RESPONSE TO SUBMISSIONS REPORT CROOKWELL 3 WF

Crookwell 3 Wind Farm Addendum Environmental Impact Statement Response to Submissions

On behalf of
Crookwell Development Pty Ltd

Figure 1 - Vegetation Mapping and Wind Farm Infrastructure
Crookwell 3 Wind Farm
Updated Vegetation Mapping

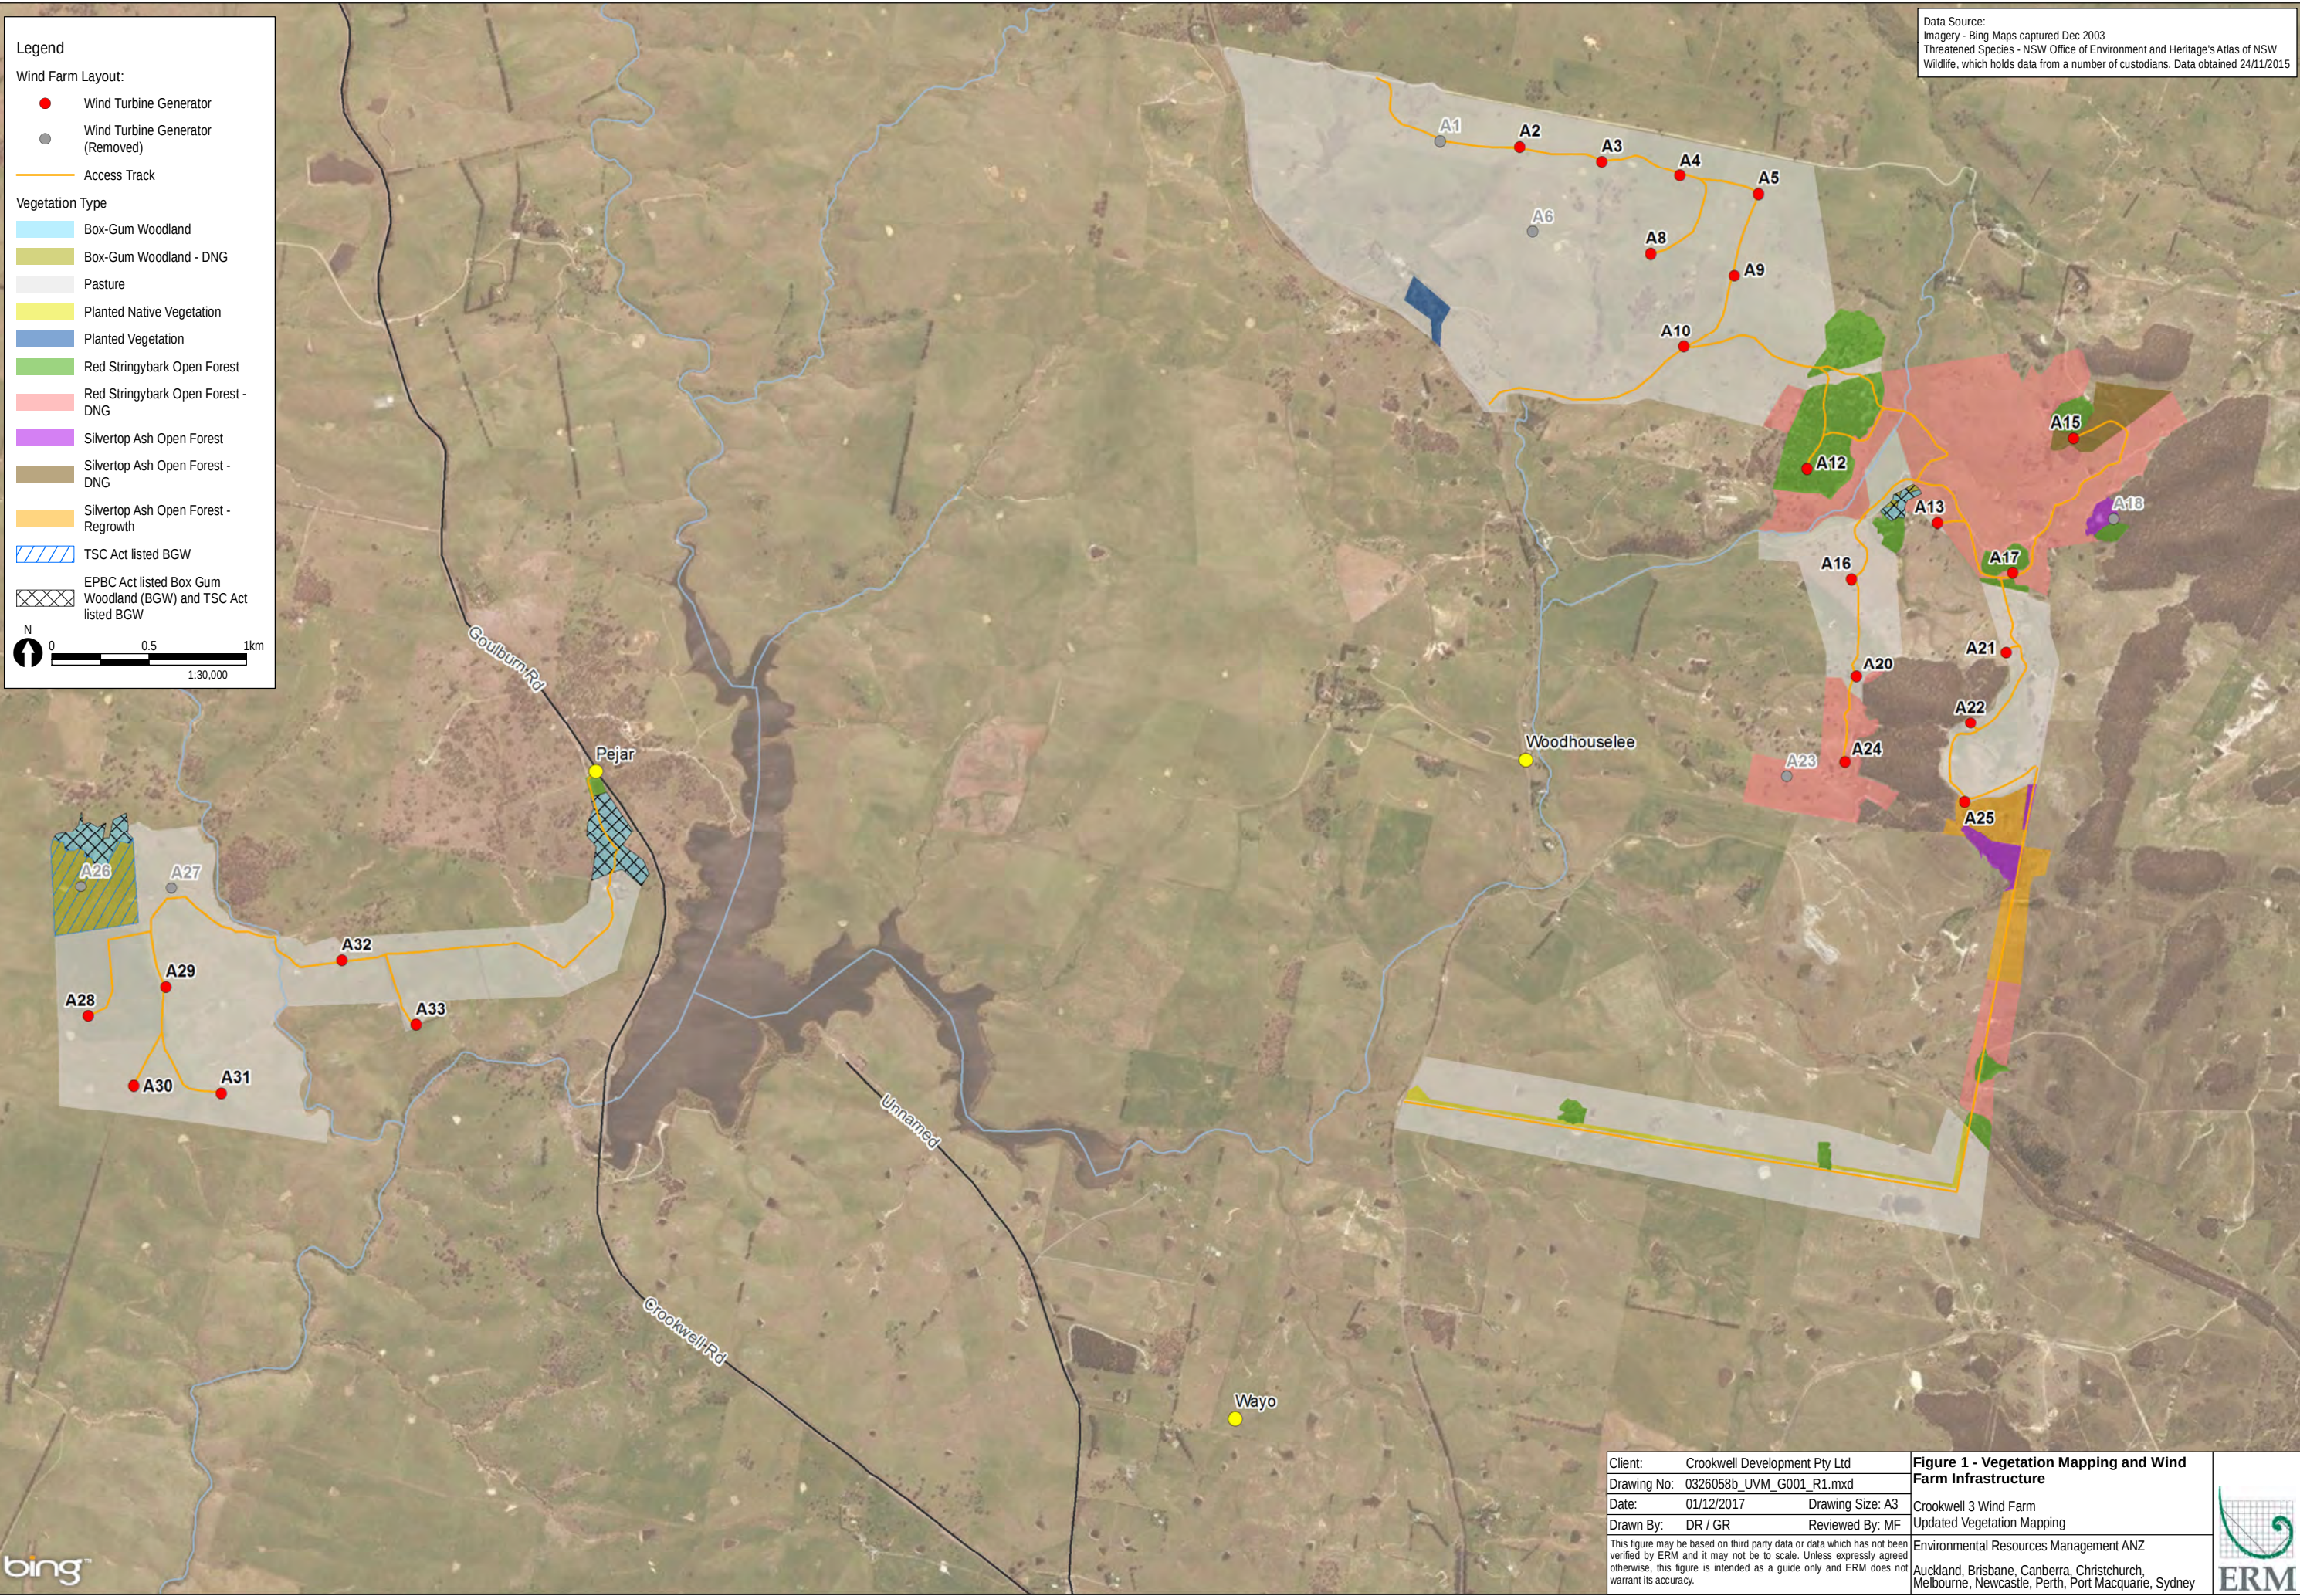
Access track realignments	Figures should be updated to show the minor changes to the alignment of access track between turbine A13 and A16 to avoid the box gum woodland. Response: Refer to Figure 1 in Appendix 6 showing the proposed footprint and vegetation mapping.
Turbine A24 realignment	Figures should be updated to show the changes of location for turbine 24. Response: Refer to Figure 1 in Appendix 6 showing the proposed footprint and vegetation mapping.
Turbine A26 and A27 removal and track realignment	OEH supports the removal of turbine A26 and A27 and the realignment of the access track. However, OEH indicates figures should be updated to show the realignment to the access track. Response: Refer to Figure 1 in Appendix 6 showing the proposed footprint and vegetation mapping.

Turbine A26 and A27 removal and track realignment	<i>OEH notes and supports the removal of turbine A26 and A27 from within the Box Gum derived native grassland path in the western part of the project area and the realignment of the access track to avoid this patch.</i> <i>However it doesn't appear that the realignment to the access track is reflected in Figure 3 - Proposed Infrastructure layout. This should be updated to reflect the changes.</i>	Refer Figure 1(attached) showing the proposed footprint and vegetation mapping.

Matter	OEH Comment	ERM Response/Advice
		vegetation will be rehabilitated with native species that are suitable to the location – in particular, areas that have been mapped as over 50% native grass will be rehabilitated with native grass species.
Access track realignments	<i>There has been a minor change to the alignment of access track between turbine A 13 and A 16 to avoid the box gum woodland. However the layout in Figures 2 and 3 in the Addendum Environmental Impact Statement doesn't look any different. These figures should be updated to show these changes.</i>	Refer Figure 1(attached) showing the proposed footprint and vegetation mapping. .
Turbine A24 realignment	<i>The Ecology report states that there has been a slight change of location for turbine A24, however it doesn't look any different between Figure 2 and Figure 3 in the Addendum Environmental Impact Statement. These figures should be updated to show these changes.</i>	Refer Figure 1(attached) showing the proposed footprint and vegetation mapping.
